Access Compliance Report

Public Rights-of-Way

(Curb Ramps)

Intersection ID: 18776	Main Street: SOUTH_BV	Cross Street: TYVOLA_RD	Location: NE
ADA ID: E9EFB4673C58	Ramp Type: Perp	Initial Pass/Fail: Pass	Overall Compliance: No
Codes/Mitigation Info/Possible Solution		Field Measurements/Component Compliance	
Severity Score: 10.25

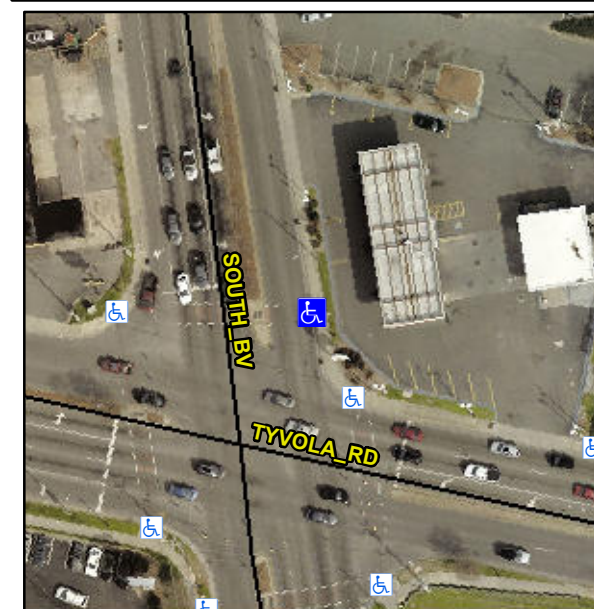
**R304.5.3, R304.2.1, R304.2.2-Perp,
R304.3.2-Para**

Compliance	Description	Data	Compliance	Description	Data
N/A	Ramp Length (in)	69.0	Yes	Ramp Slope (%)	7.5
Yes	Ramp Width (in)	48.0	No	Ramp XSlope (%)	2.3
N/A	Flare Type LT	Sloped	N/A	Flare Type RT	N/A
N/A	Flare Slope LT (%)	6.2	Yes	Flare Slope RT (%)	4.5
N/A	Flare Traversable LT?	Yes	N/A	Flare Traversable RT?	Yes
No	Landing Length (in)	N/A	Yes	DWS Provided?	Yes
No	Landing Width (in)	N/A	Yes	DWS Contrast?	Yes
No	Landing Slope (%)	N/A	Yes	DWS Length (in)	24.0
No	Landing X Slope (%)	N/A	Yes	DWS Full Width?	Yes
N/A	Landing Curb? (Y/N)	Yes	Yes	DWS Offset (in)	0.0
N/A	Shared Landing?	No			
Yes	Gutter Ponding?	No	Yes	Gutter Slope (%)	4.3
Yes	Gutter Lip Ht (in)	0.0	Yes	Gutter X Slope (%)	1.3
N/A	Painted X Walk1?	Yes	N/A	Painted X Walk2?	N/A
	X Walk 1 Direction	To W		X Walk 2 Direction	N/A
N/A	X Walk 1 Width (in)	116.0	N/A	X Walk 2 Width (in)	N/A
	X Walk 1 Slope (%)	2.9		X Walk 2 Slope (%)	N/A
	X Walk 1 X Slope (%)	1.0		X Walk 2 X Slope (%)	N/A

Remove & Replace Entire Ramp.
